FORD:

2015-2017 Mustang

Figure 1 - Article 16-0103

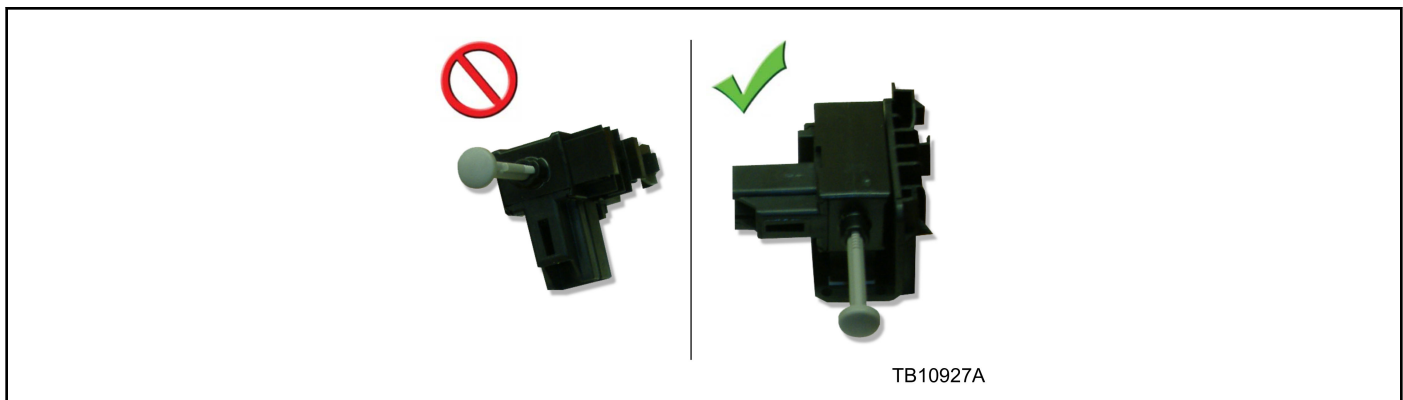
Some 2015-2017 Mustang vehicles equipped with a manual transmission and built on or before 6/15/2016 may exhibit a no crank condition due to the clutch pedal position (CPP) switch being damaged.

1. Inspect the CPP switch for physical damage. Is the CPP switch damaged?
 - a. Yes - proceed to Step 2.
 - b. No - this article does not apply.
2. Install a new CPP switch and bracket. Refer to Workshop Manual (WSM), Section 303-14. The switch includes a plastic bracket rotating the connector 90 degrees. (Figure 1)
